ADDENDUM NO. 11

PROJECT TITLE - PA State Police Greensburg - DNA Laboratory Facility New Building

ADDENDUM 11

MEP REVISION #1 - 11/15/2022

DRAWN BY: E HOOVER DATE: 05/24/2022 DRAWING NO.: **E101**
 CHECKED BY: S MULHOLLEN SCALE: 1" = 40'-0" (VOLUME 1 OF 1)

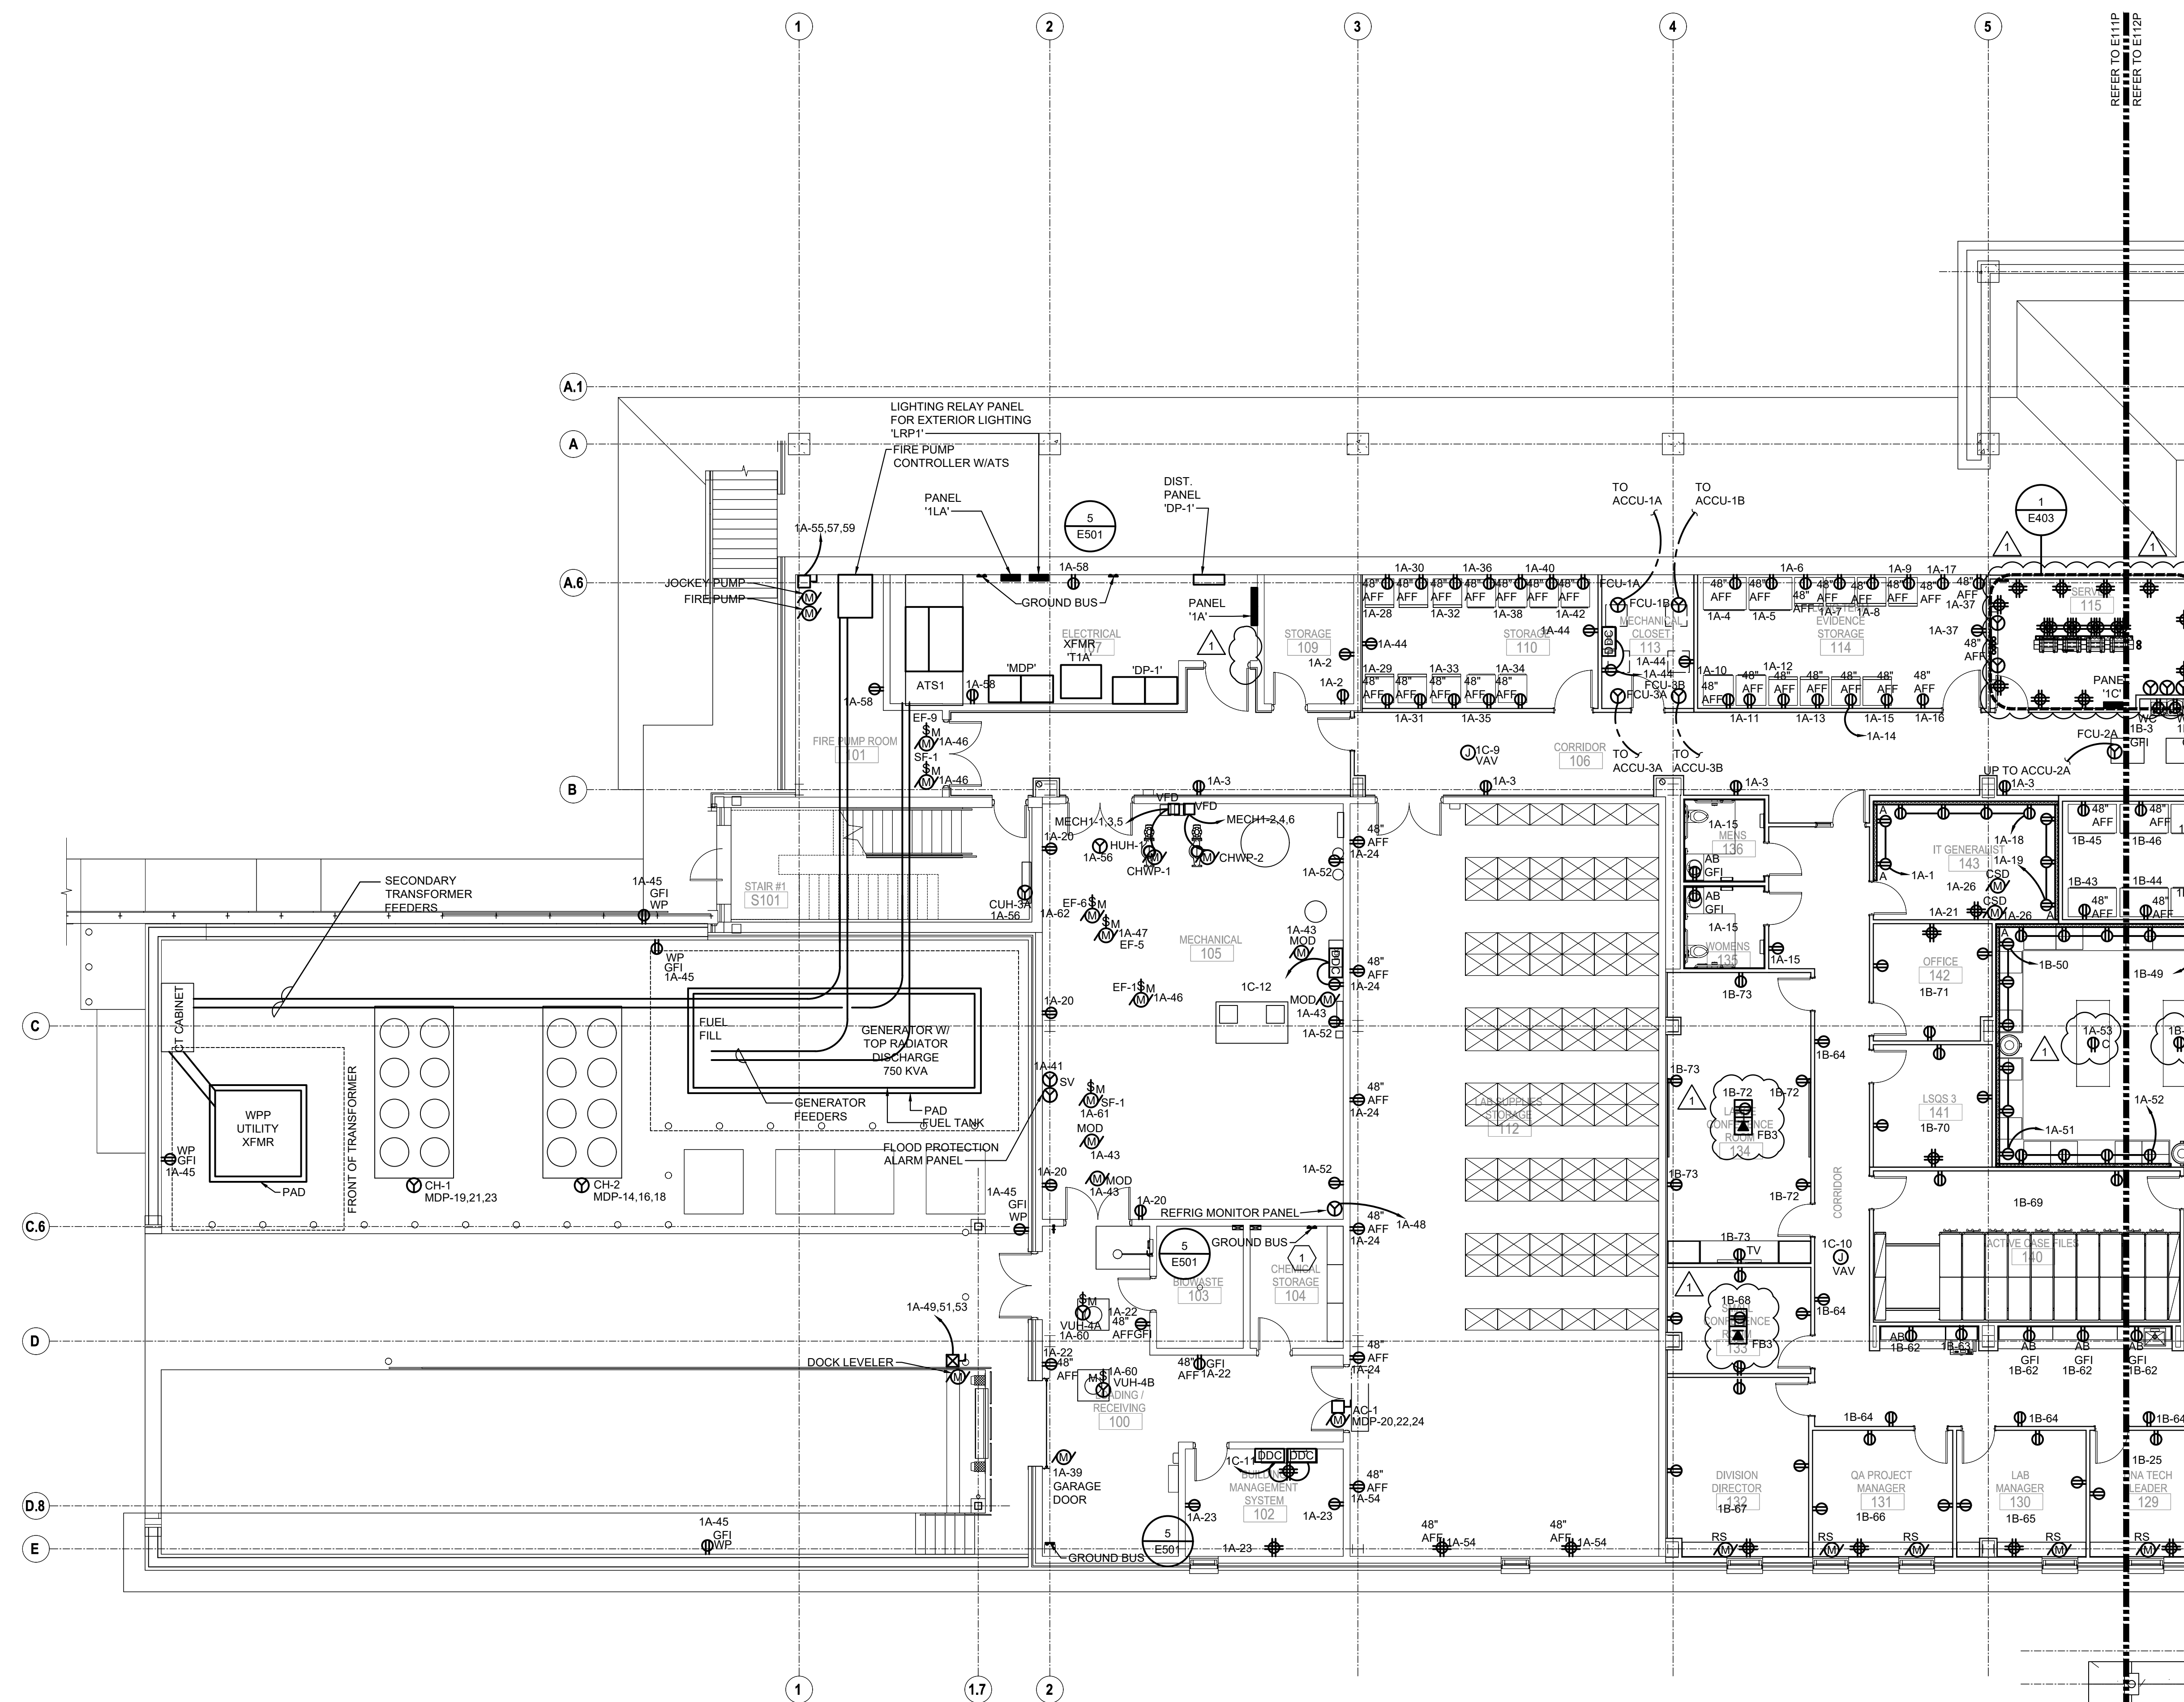
- E001 - Updated description for "Double Compartment Surface Metal Raceway".
- E101 - Added (2) 4" conduit to ductbank for a total of (4) 4" conduits routed to Telecom Room.

DRAWN BY E HOOVER	DATE 05/24/2022	DRAWING NO. E111P
CHECKED BY S MULHOLLEN	SCALE 1/8" = 1'-0"	(VOLUME 1 OF 1)

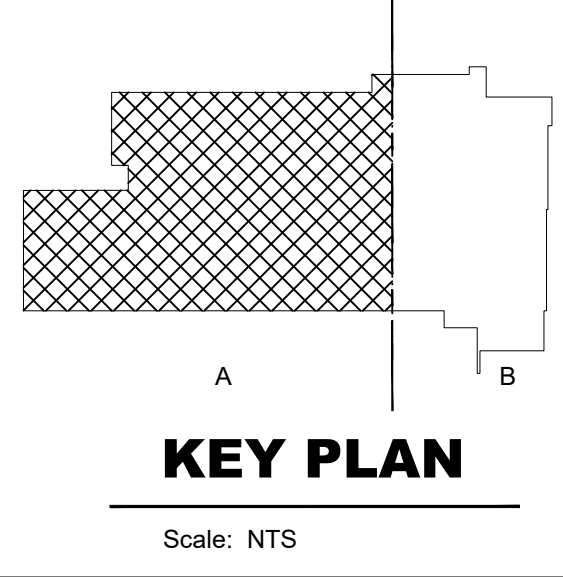
- E111P - Added identification tag for Floor box in rooms 133 and 134.
- E111S - Added identification tag for Floor box in rooms 133 and 134.
- E111P/E112P - Updated tag for ceiling mounted receptacles in room 139.

- E111P/E112P - Revised Telecom Room 115 layout per client agency comments.
- E111S/E112S - Revised Telecom Room 115 layout per client agency comments.
- E111P - Relocated panel "1C" from Electrical Room 107 to Telecom Room 115.

DRAWN BY E HOOVER	DATE 05/24/2022	DRAWING NO. E112P (VOLUME 1 OF 1)
CHECKED BY S MULHOLLEN	SCALE 1/8" = 1'-0"

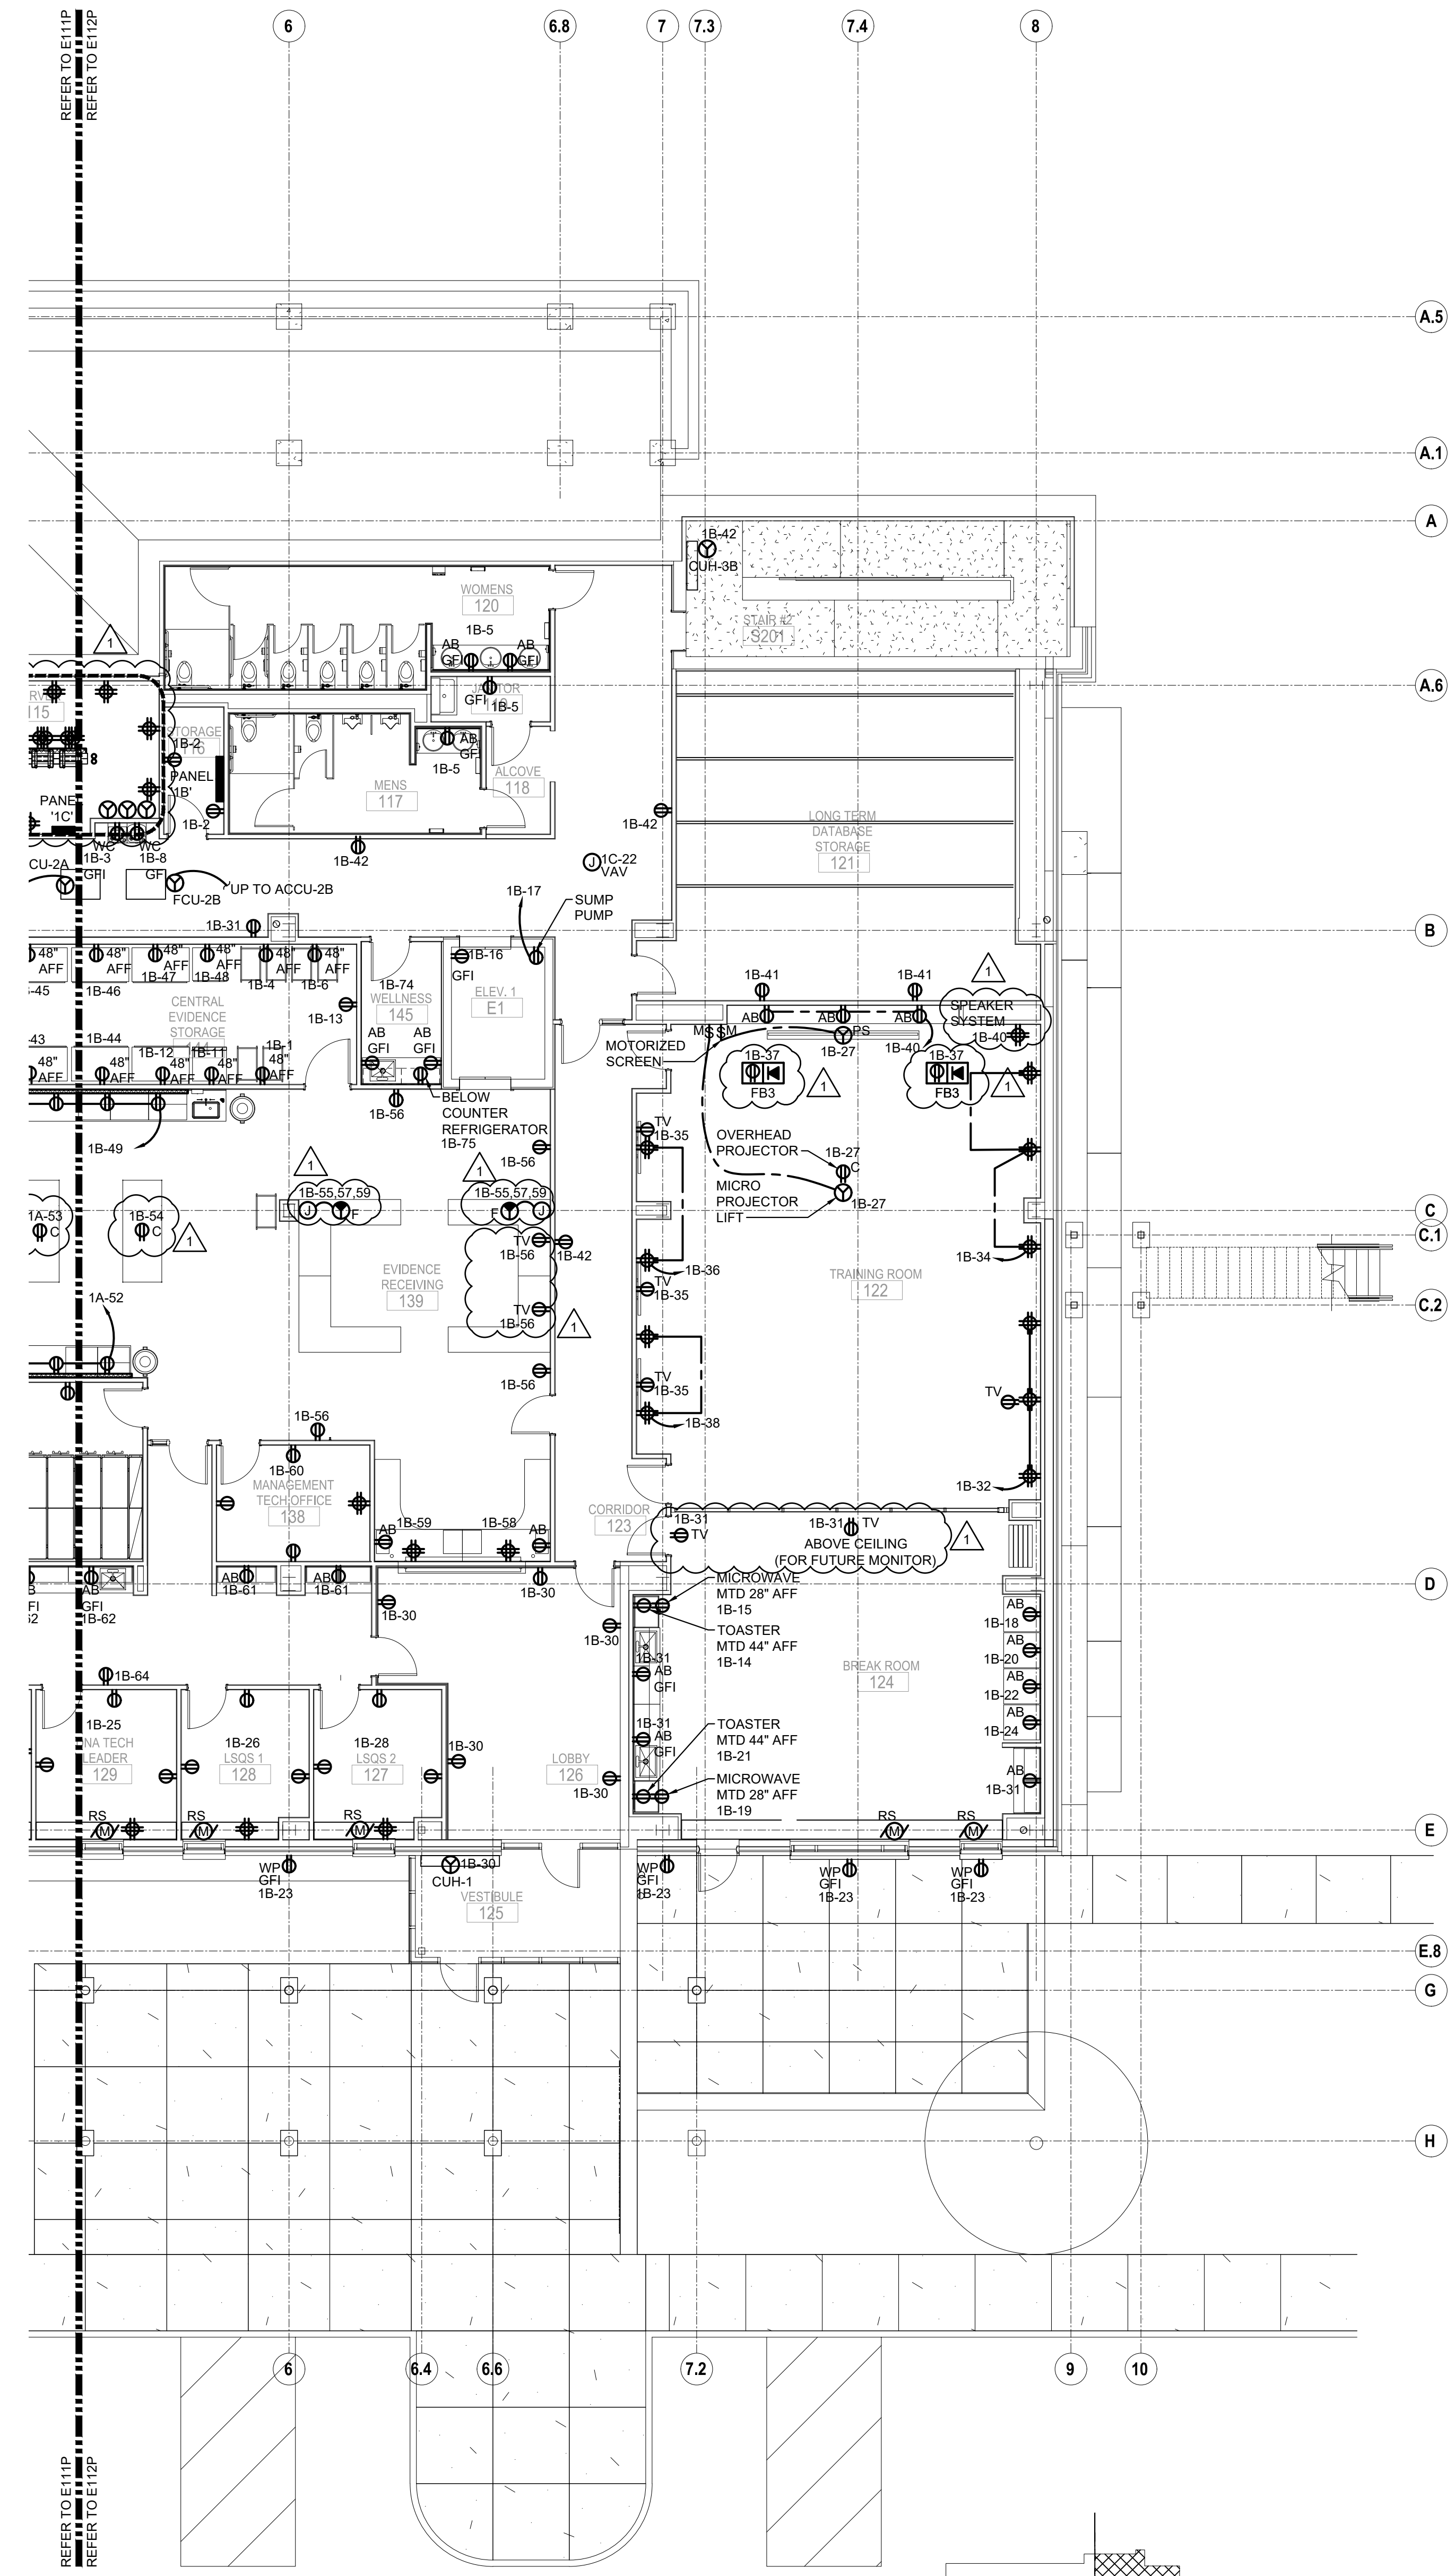
- E112P - Added receptacles for (2) security monitors in Room 139, added to circuit '1B-56'.
- E112P - Added power for TV monitor above door in room 124, added to circuit '1B-31'.

- E112P - Added power for future TV monitor (above ceiling) in room 124, added to circuit '1B-31'.
- E112P - Added AV receptacle for speaker system in room 122, added to circuit '1B-40'.

E112P - Added (2) Floor boxes in room 122, assigned to circuit "1B-37"
